**CITY OF ST. PETERSBURG, FLORIDA
PLANNING & DEVELOPMENT SERVICES DEPT.
DEVELOPMENT REVIEW SERVICES DIVISION**

STAFF REPORT

DEVELOPMENT REVIEW COMMISSION - VARIANCE REQUEST PUBLIC HEARING

CASE NO.: 20-54000056 PLAT SHEET: I-8

SITE PLAN

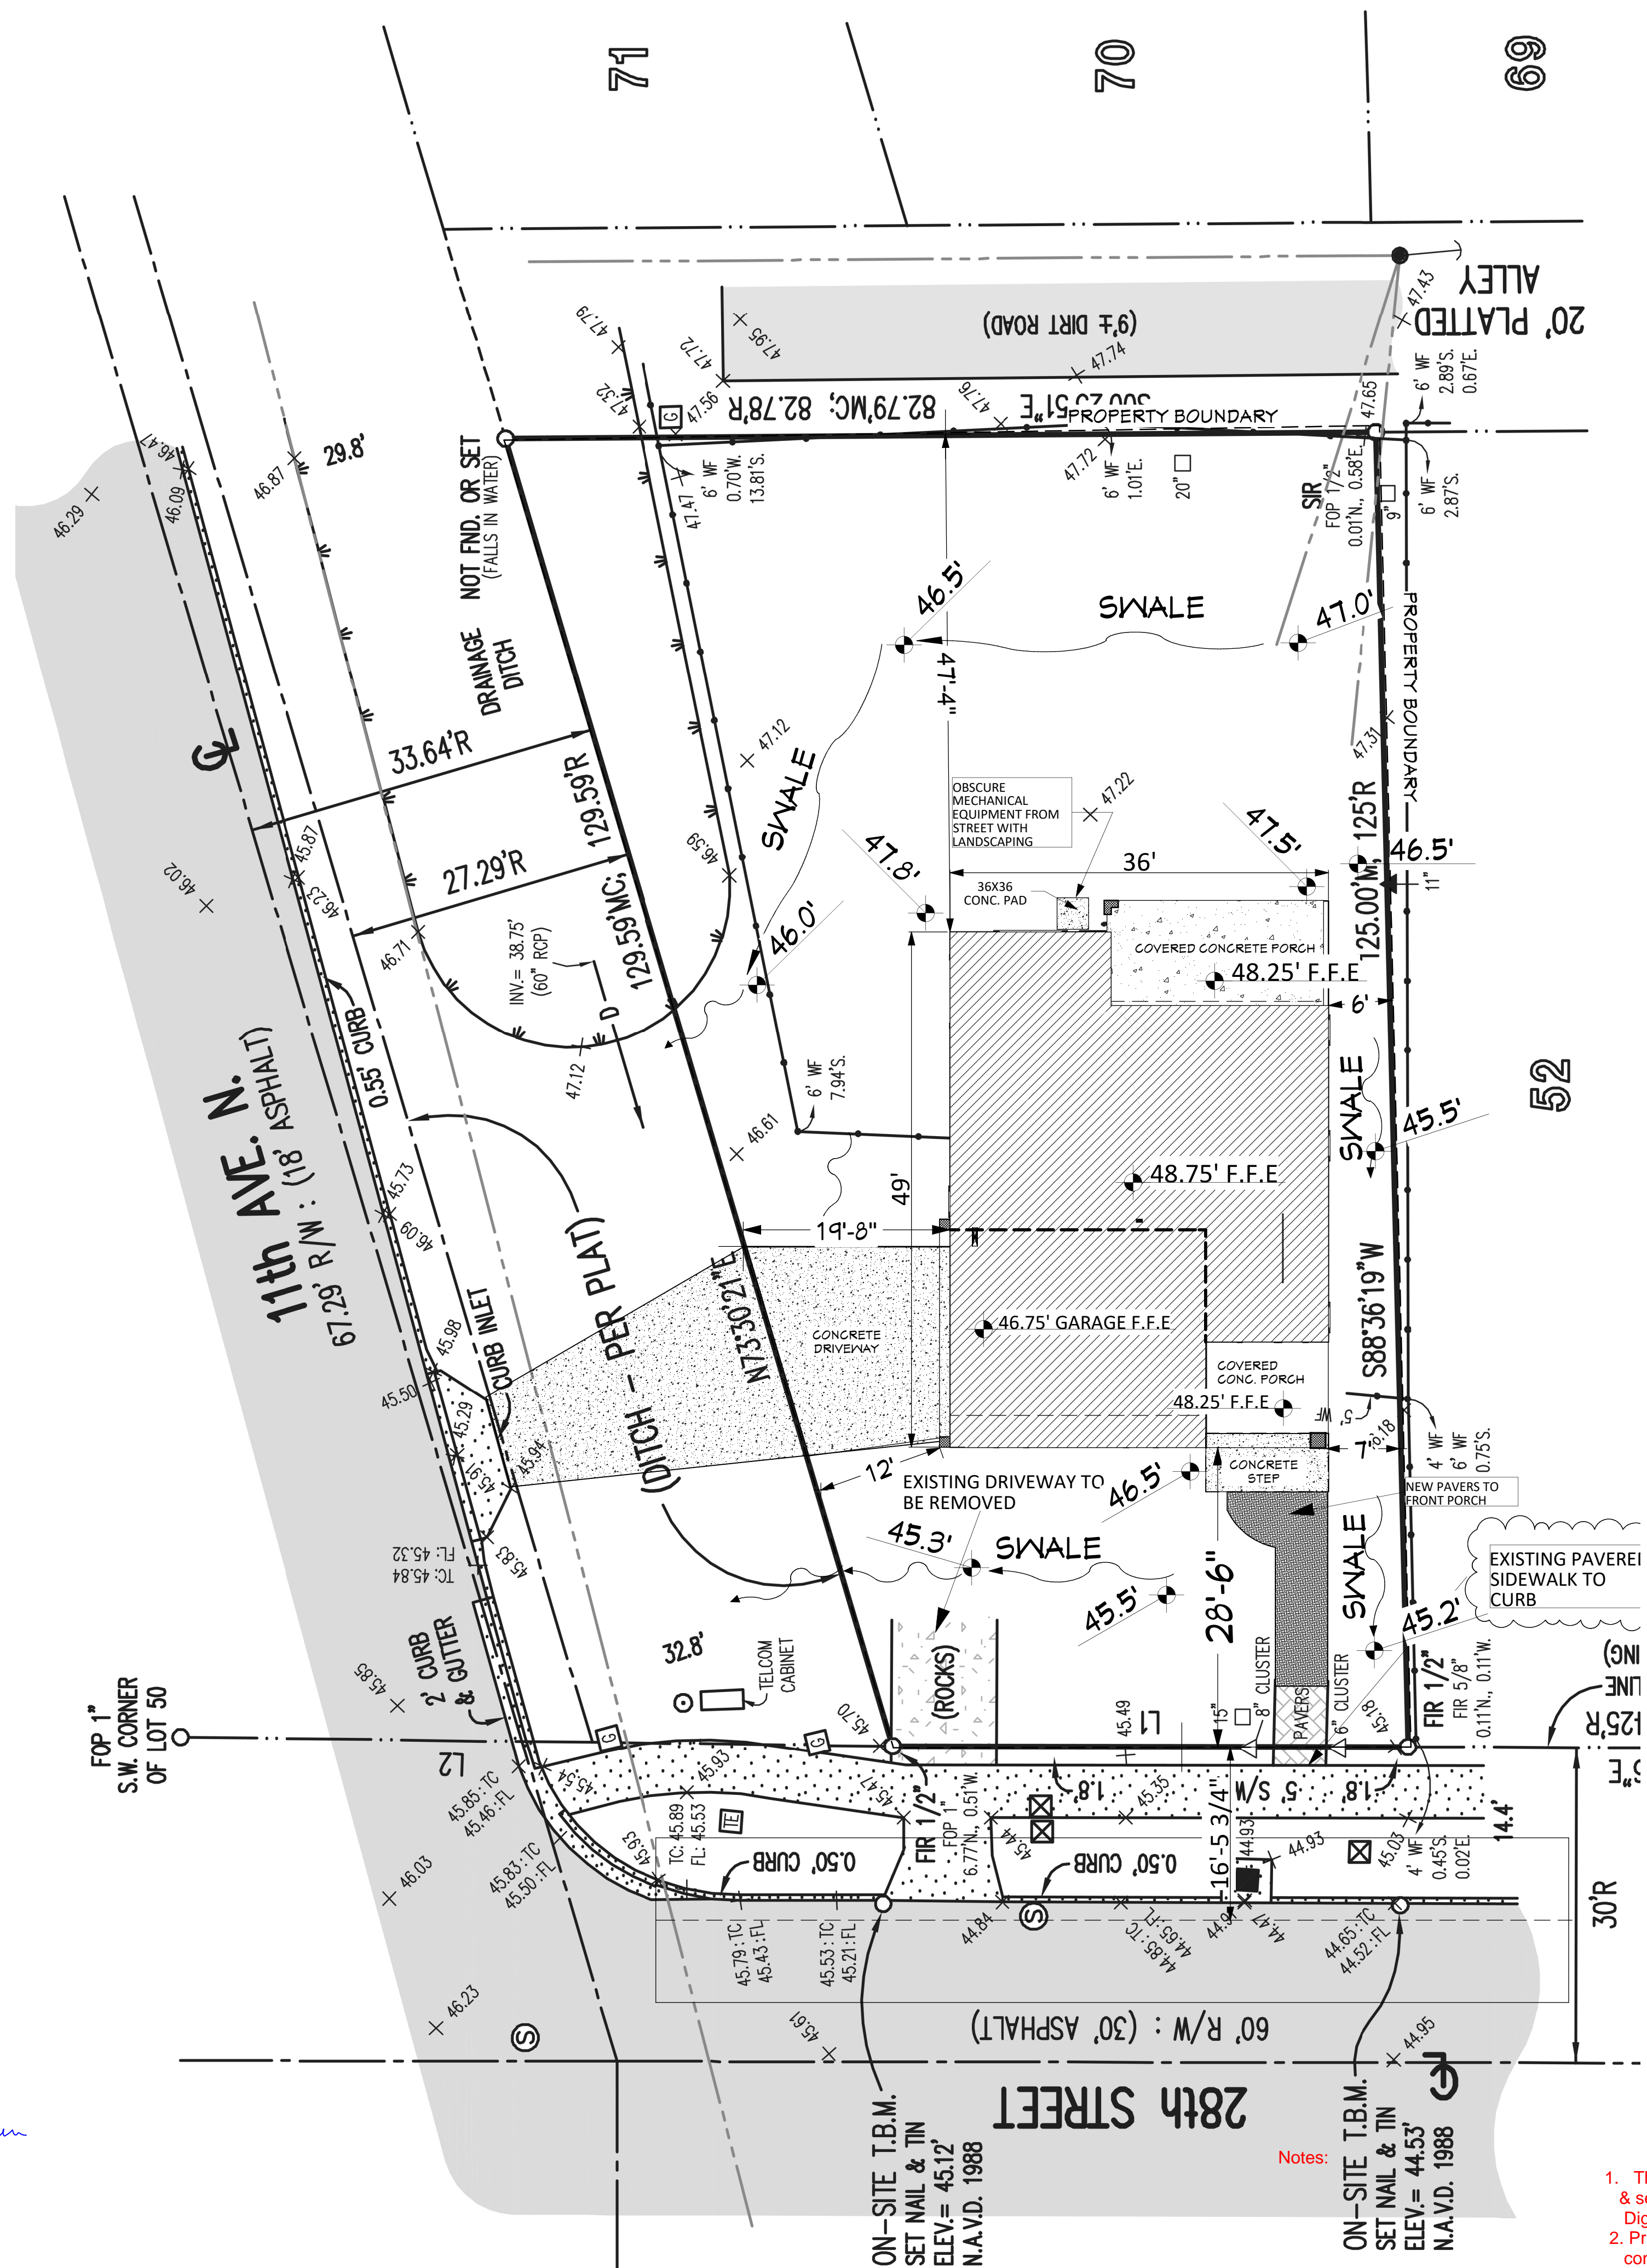
This request is to allow a driveway access from the side street (11th Avenue North), rather than the alley in the rear. The existing front-loaded driveway would be removed.

The subject lot meets all required size dimensions. A navigable alley exists in the rear of the property, though it dead ends just north of the property.

A literal enforcement of this chapter would not result in unnecessary hardship. The navigable alley in the rear can be used to access the property. The alley dead ends directly to the north of the subject property, but this does not make entering and exiting the property via the alley impossible.

A literal enforcement of this chapter does not deprive the applicants of reasonable use of their land as the property has 89-feet of frontage to this navigable alley. Many of the other homes abutting this alley utilize it for parking.

The variance requested is not the minimum variance that will make possible the reasonable use of the land as the site can accommodate parking and a driveway from the rear without a variance.

This request is not in harmony with the general purpose and intent of this chapter as section 16.20.010.11 states that garage doors and driveways shall face the alley. Additionally, section 16.60.030.1 states that nonconforming structures (i.e. the existing driveway) are not allowed within a zoning district. These non-conforming structures are not encouraged to survive and must be replaced with code-compliant structures when the site is redeveloped.

The granting of this variance presents a potential risk for pedestrians as cars will traverse the sidewalk when entering and existing private property. Though there is no existing sidewalk along 11th Avenue north at this time, Traditional neighborhoods are intended to have a pedestrian focus rather than a car focus. An alley in the rear of the property provides the necessary access for parking of vehicles on private property.

STAFF RECOMMENDATION: Based on a review of the application according to the stringent evaluation criteria contained within the City Code, the Planning and Economic Development Department Staff recommends **DENIAL** of the requested variance.

1. The driveway must be designed with a maximum width of 12-feet as measured at the property line and 16-feet as measured at the curb.
2. This variance approval shall be valid through January 6th, 2023. Substantial construction shall commence prior to this expiration date. A request for extension must be filed in writing prior to the expiration date.
3. Approval of this variance does not grant or imply other variances from the City Code or other applicable regulations.
